Access Compliance Report

Public Rights-of-Way

Main Street: **YORKSHIRE_AVE** Cross Street: **NEARING_DR** Location: **SE**

ADA ID: **RPRK210928130702** Ramp Type: **Type 1 - Perpendicular Diagonal Initial Pass/Fail: Fail** Overall Compliance: **No** Severity Score: **15**

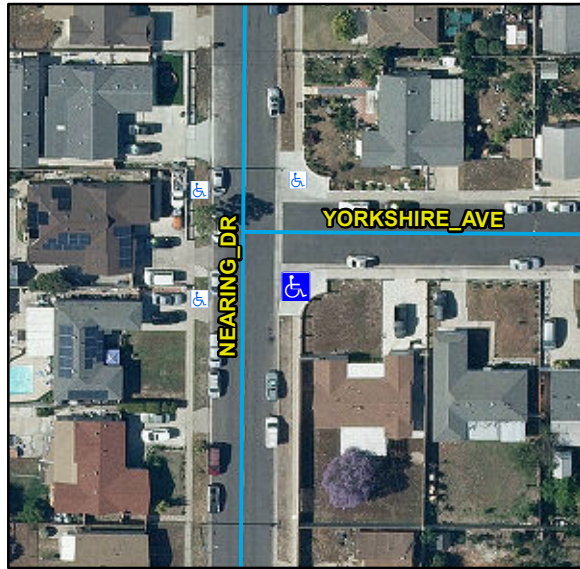
Compliance	Description	Data	Compliance	Description	Data
N/A	Ramp Length (in)	145	N/A	Flare Type LT	
Yes	Ramp Width (in)	48			N/A
No	Ramp Run Slope (%)	10.4	N/A	Flare Slope LT (%)	N/A
Yes	Ramp Cross Slope (%)	2.6	N/A	Flare Traversable LT	N/A
N/A	Landing Present	N/A	N/A	Flare Type RT	
N/A	Landing Length (in)	N/A			N/A
N/A	Landing Width (in)	N/A	N/A	Flare Slope RT (%)	N/A
N/A	Landing Run Slope (%)	N/A	N/A	Flare Traversable RT	N/A
N/A	Landing Cross Slope (%)	N/A	N/A	DWS Provided	N/A
N/A	Landing Movement Obstructed?	N/A	N/A	DWS Contrast	N/A
	Landing Movement Type	N/A	N/A	DWS Length (in)	N/A
N/A	Landing Shared	N/A	N/A	DWS Full Width	N/A
N/A	Clear Space	Yes	N/A	DWS Offset Left (in)	N/A
N/A	Clear Space To Crosswalk (in)	N/A	N/A	DWS Offset Right (in)	N/A
N/A	Marked Crosswalk 1	No	N/A	Marked Crosswalk 2	No
	Crossing 1 Direction	N		Crossing 2 Direction	E
	Marked Crosswalk 1 Width (in)	N/A		Marked Crosswalk 2 Width (in)	N/A

N/A	Ramp Inside Crosswalk 1	N/A	Yes	Ramp Inside Crosswalk 2	N/A
	Crossing 1 Slope (%)	9.3		Crossing 2 Slope (%)	2.3
	Crossing 1 Cross Slope (%)	2.7		Crossing 2 Cross Slope (%)	1.2
N/A	Gutter Ponding	N/A	No	Curb Slope	9.1
Yes	Gutter Lip Height (in)	0		Road Run Slope (%)	3.6
N/A	Gutter Run Slope (%)	N/A		Road Cross Slope (%)	3.7
N/A	Gutter Cross Slope (%)	N/A			
Yes	Overall Surface Condition: Acceptable		Yes	Perp Joint Present	Yes
	Cross Gutter Present?	Yes		Spandrel Present?	Yes
	Replace Cross Gutter?	No		Replace Spandrel?	No

Remove & Replace Curb Ramp With Two New Directional Ramps or Equivalent.

R304.2.2, STD 1115
